Cobra Motorcycle Mfg.

TSB1304: 2004 CM & King secondary shaft bearing retainer

April 2, 2004

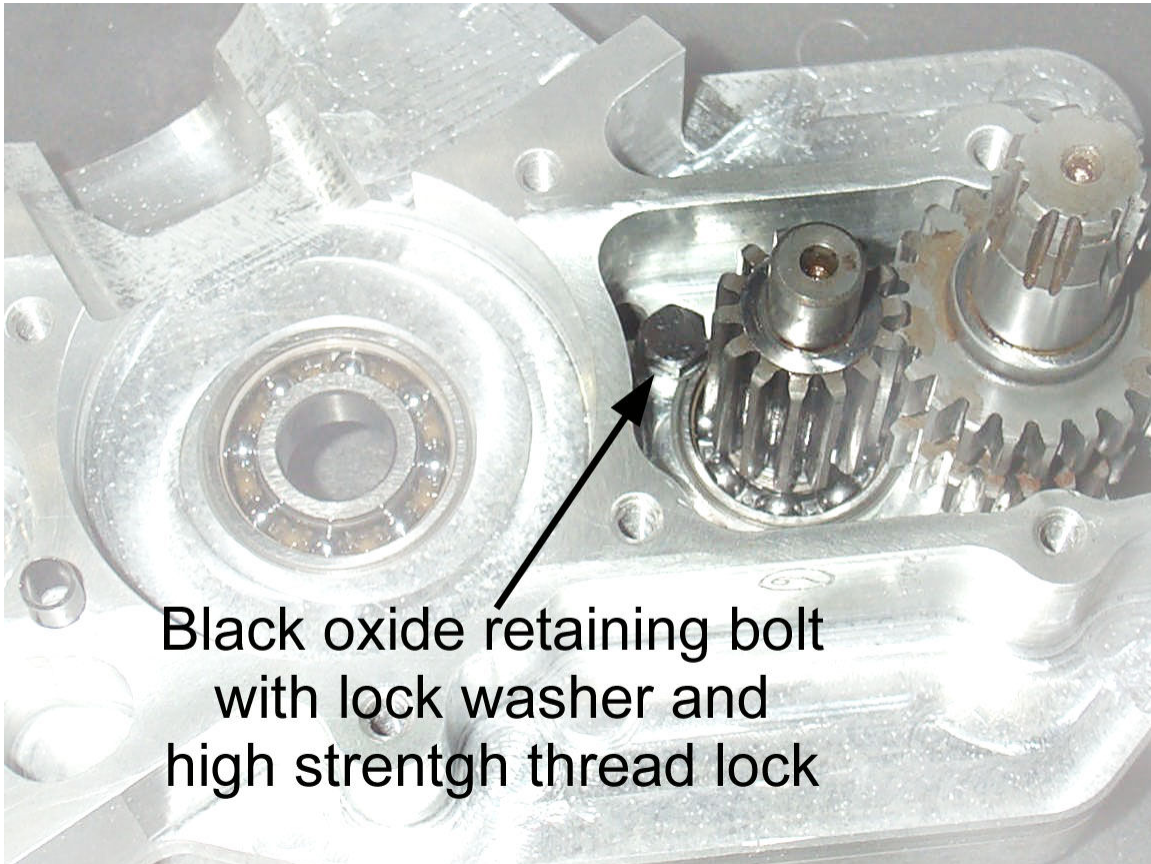
There is a slim chance (but possible none the less) that the secondary shaft bearing retainer (screw) can back out of it's intended position.

If this retainer comes out of position it can cause an immediate stop to the motorcycle and has to potential to cause substantial damage to the engine.

The early button head screw (with high strength thread locking agent) has been replaced with a black oxide bolt, lock washer, and high strength thread locking agent.
